SYAMA PRASAD MOOKERJEE PORT,KOLKATA

HALDIA DOCK COMPLEX

**Mechanization of Berth No. 05 (Erstwhile Berth No. 4B) on Design, Build, Finance, Operate,
Transfer (“DBFOT”) basis at Haldia Dock Complex**

RFQ-Pre bid replies of Mechanization of Berth No. 5 on Design, Build, Finance, Operate, Transfer (“DBFOT”) basis” at Haldia Dock Complex for a concession period of Thirty (30) years

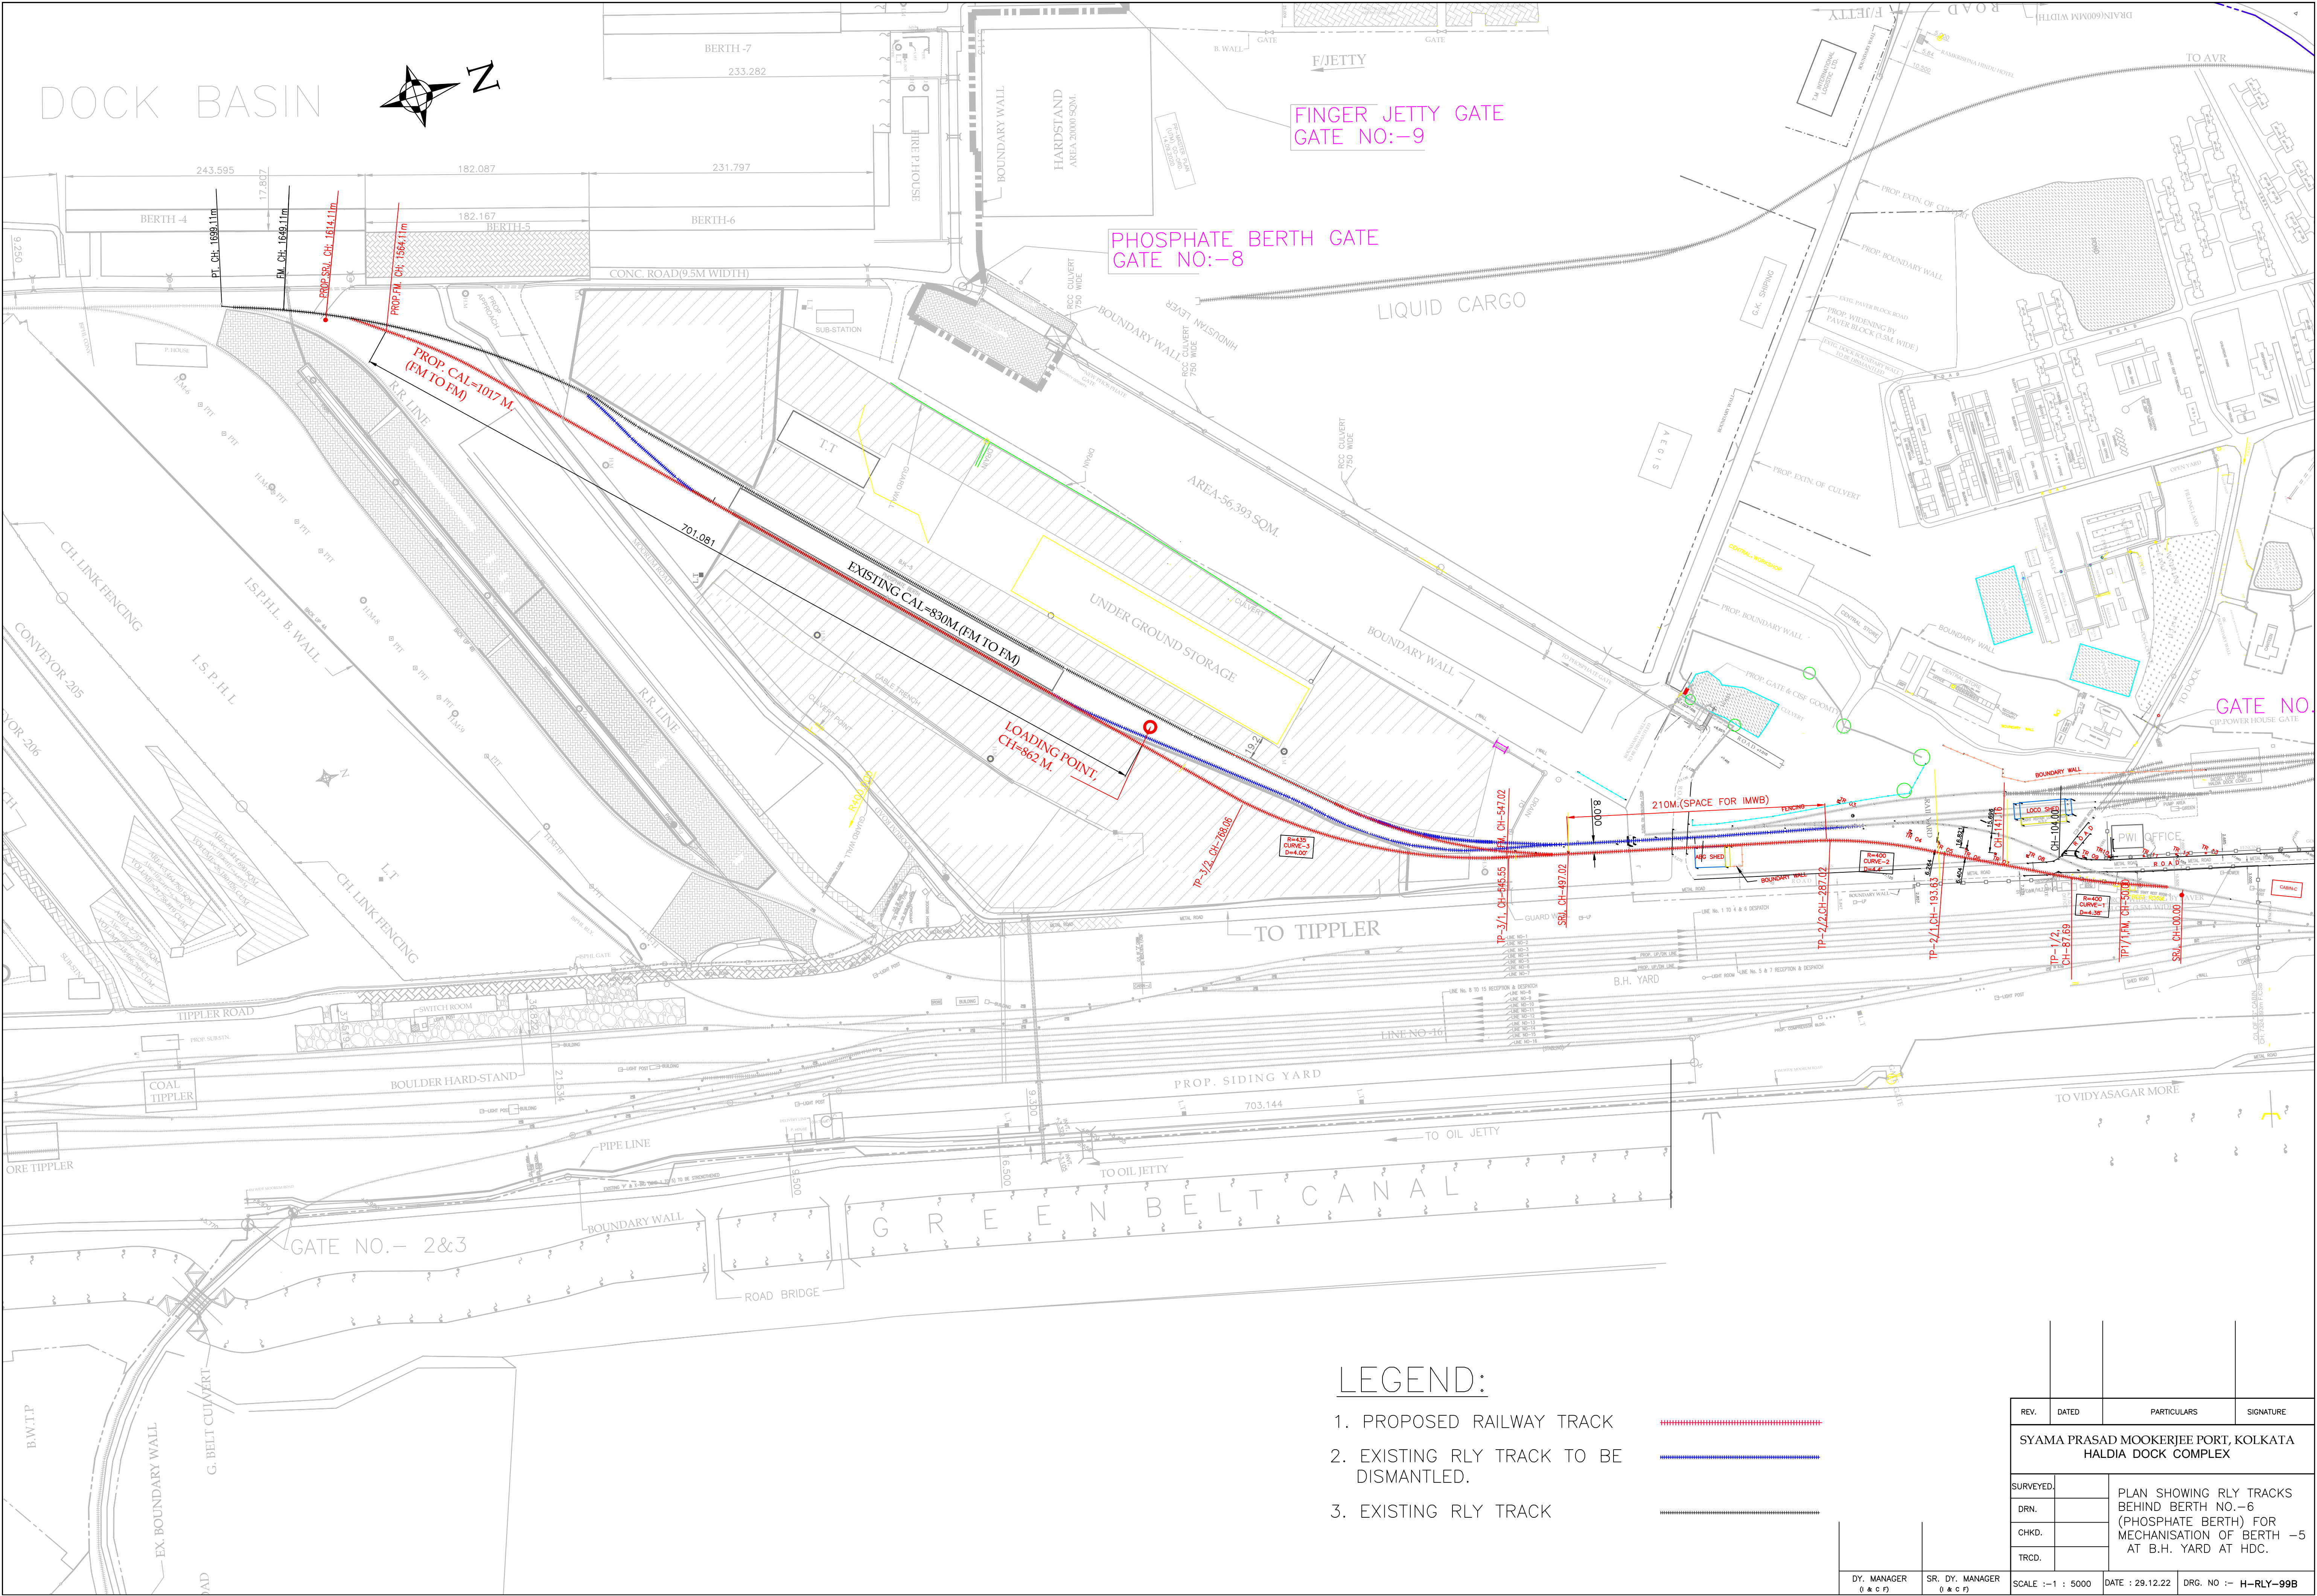
37.	Clause no 7.9 (TEFR)	Table 7-9: General Specifications of Wagon Loading Station (Page no-191)	Each of the two existing railway tracks is of 1000 Mtrs length which can accommodate max 60 boxes. Currently 58/60 boxes per rake which is in vogue, will soon be upgraded and increased to 70 / 75 boxes per rake, wherein the free time will be 3 to 3 and a half hours. Keeping the forthcoming scenario in mind, is there any provision for increasing the track length?	Two existing tracks are available in which first existing line is around 750 m and same shall be extended on both the end connect with 2 nd Line by the concessionaire own cost, for accommodating max 59 boxes (one full rake). Second line is of 1570m length which can used for escape line.

38.	Clause no 5.6.1 & Table 7.9 (TEFR)	5.6.1 Wagon Loading Station (WLS) (Page no-151) & Table 7-9: General Specifications	Whether OHE Line will be provided by port for movement of electric powered locos	Currently, HDC does not have the OHE. However, the concessionaire is free to develop the OHE line if required at his own cost, for movement of Electric power locomotive. However, the OHE plan

Sl.no	Clause Reference	Particulars	Queries / Observation	Response of HDC, SMP, KOLKATA
		of Wagon Loading Station (Page no-191)		and designs to be duly approved by HDC before implementation. Meanwhile, it is proposed for using diesel locomotive by the Concessionaire, at his own cost.
